BURLINGTON DEVELOPMENT REVIEW BOARD

Tuesday, September 15, 2020, 5:00 PM

TO: Development Review Board
FROM: Ryan Morrison, Associate Planner
DATE: September 15, 2020
RE: 21-0144SD; 95 Derway Drive

TO: Development Review Board
FROM: Ryan Morrison, Associate Planner
DATE: September 15, 2020
RE: 21-0116CA; 24 Alexis Drive

Civil plans C2.2 and C4.2 and Plan A8 define the gravity wall as terraced with plantings.

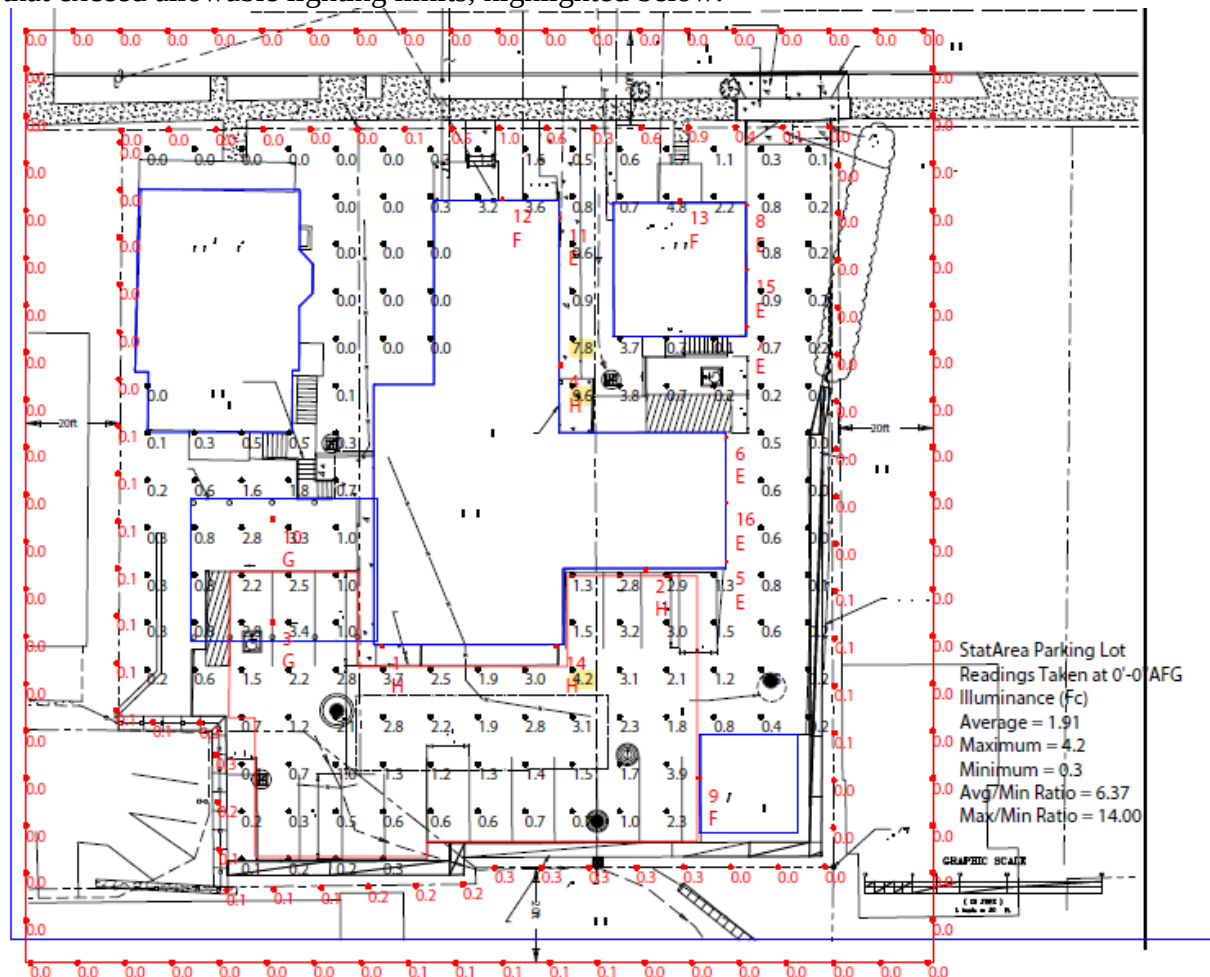
Retaining walls greater than 5 feet tall shall incorporate textured surfaces, terracing, and/or vegetation to avoid long monotonous unarticulated expanses and to minimize adverse visual impacts to neighboring properties. As with fences, retaining wall styles, materials, and dimensions shall be compatible with the context of the neighborhood and use of the property.

Heights vary from 2-12'. As the involved properties all sit on the cusp of the Burlington Ravine and have consistently struggled with the changing grade inherent to their site, this is the context of the neighborhood. Review of retaining walls greater than 3' in height is the responsibility of the City Engineer. **Affirmative finding as conditioned.**
